Technical change of the contact foot for the ZPE 2.5 protective earth terminal blocks

Technische Änderung des Kontaktfußes der ZPE 2.5 Schutzleiterreihenklemmen

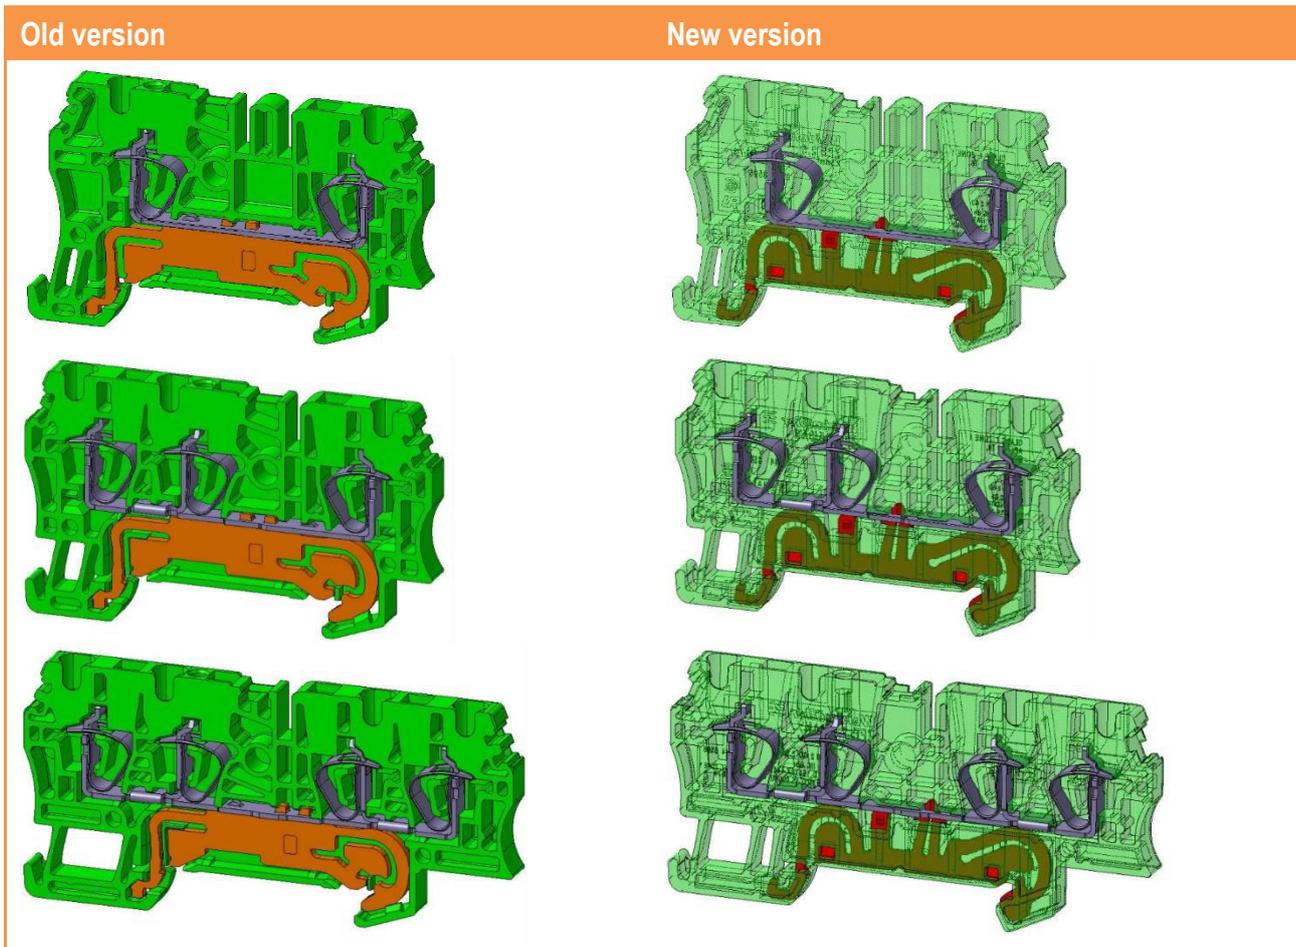
The ZPE 2.5 protective earth terminal blocks are completely open at the side. The clamping units and the contact foot of the ZPE 2.5 protective earth terminal blocks are therefore directly visible from the side.

The shape of the contact foot has been changed slightly. In addition, the contact foot is now integrated into the moulding and is no longer visible directly from the side. The technical properties of the ZPE 2.5 protective earth terminal blocks are not affected by the change!

The change was made as part of a product optimisation. The change also ensures the further standardisation of the protective earth terminal block portfolio and contributes to the stabilisation of the product quality.

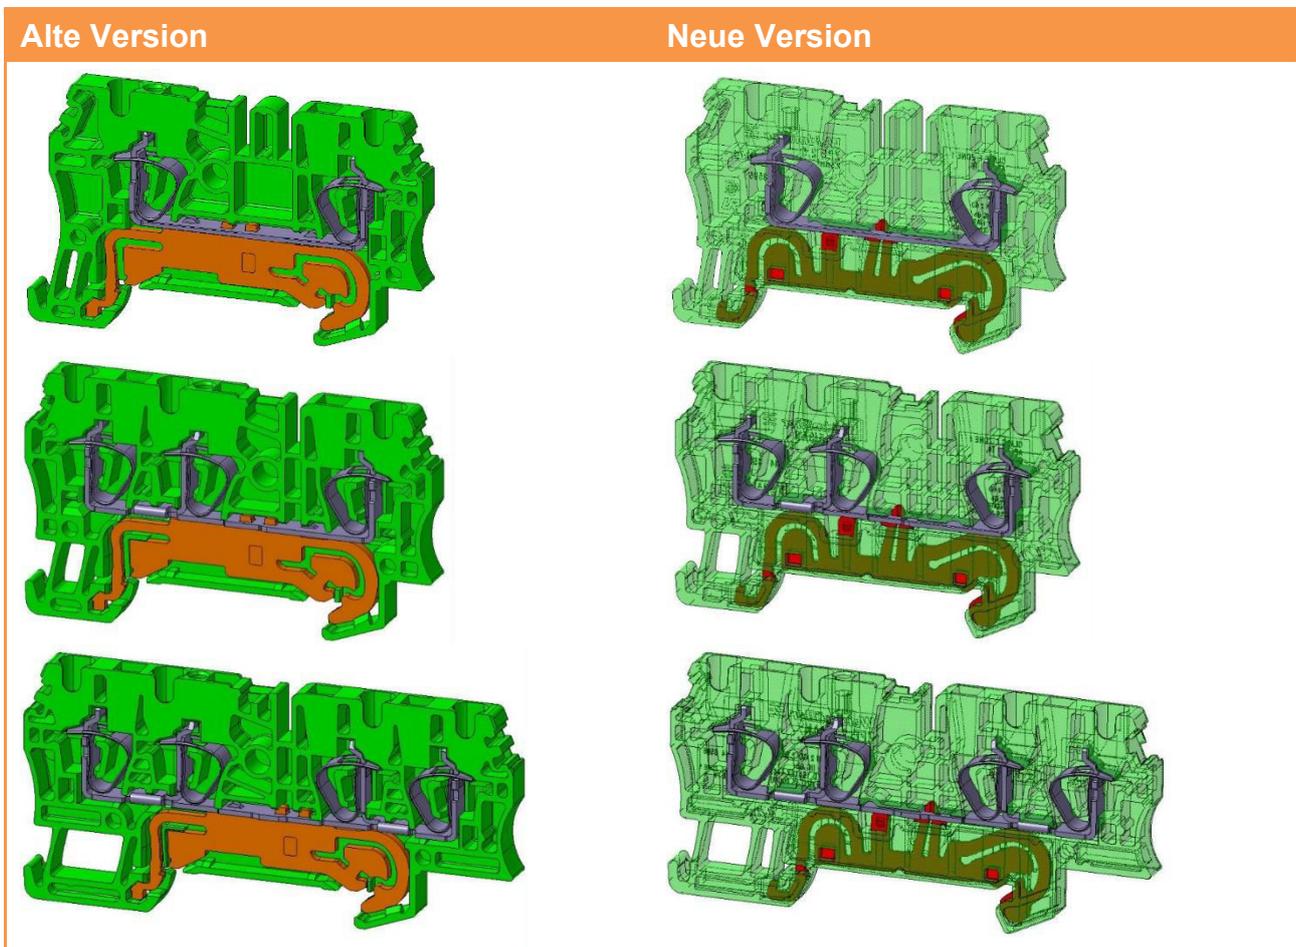
Die ZPE 2.5 Schutzleiterreihenklemmen sind seitlich komplett geöffnet. Die Anschlüsse sowie der Kontaktfuß der ZPE 2.5 Schutzleiterreihenklemmen sind dementsprechend direkt von außen sichtbar.

Die Kontur des Kontaktfußes wurde leicht verändert. Zusätzlich wird der Kontaktfuß fortan in den Klemmenträger eingelassen und ist nicht mehr direkt sichtbar. Die technischen Eigenschaften der ZPE Schutzleiterreihenklemmen sind von der Änderung nicht betroffen!

Die Änderung wurde im Rahmen einer Produktoptimierung durchgeführt. Die Änderung sorgt ebenfalls für die weitere Vereinheitlichung des Schutzleiterreihenklemmen Portfolios und trägt zur Stabilisierung der Produktqualität bei.
